## SERVICE BULLETIN

AUTOMATIC AIR ENTRY WINDOW INTO THE BALANCE JAR (AIRBOX) FOR ENGINES ROTAX 80HP TURBO CHARGED.

**SB-Ibis-003**

Modified jar lid to balance the Turbo System (Airbox)

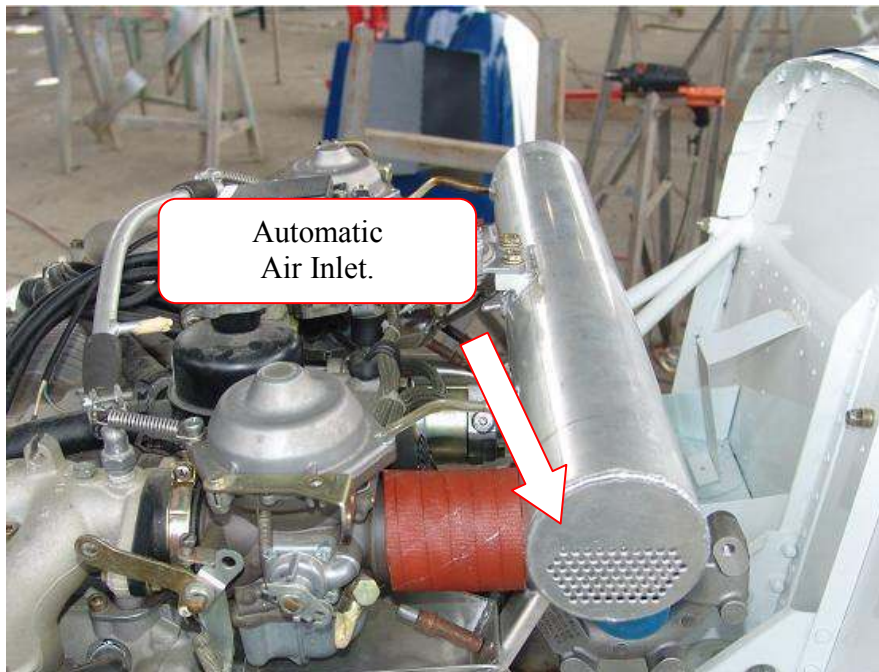
**INSTRUCTION.** In the balance Jar (Airbox), where the automatic air inlet is located a modification should be made, this system should be abolished and be replaced by a manual system operated by a cable from inside the cabin.

You must remove the lid where the automatic air inlet is located, in order to realize a new one with a modification, and keeping the same diameter of the balance jar of the Turbo system (Airbox), the modification consists in making an air inlet in the center of the new lid that is activated by a manual cable from inside the cabin. As shown in the illustration.

This lid should keep the internal diameter of the Turbo System's balance jar (Airbox) to introduce in it , once this process is done, weld the lid to the balance jar (Airbox) and then adapt a cable in the system to be manually operated from inside of the cabin.

*"Closed" air inlet. Setting to operate the Turbo system Turbo*

*“Open” Air inlet Setting Normally Aspirated*
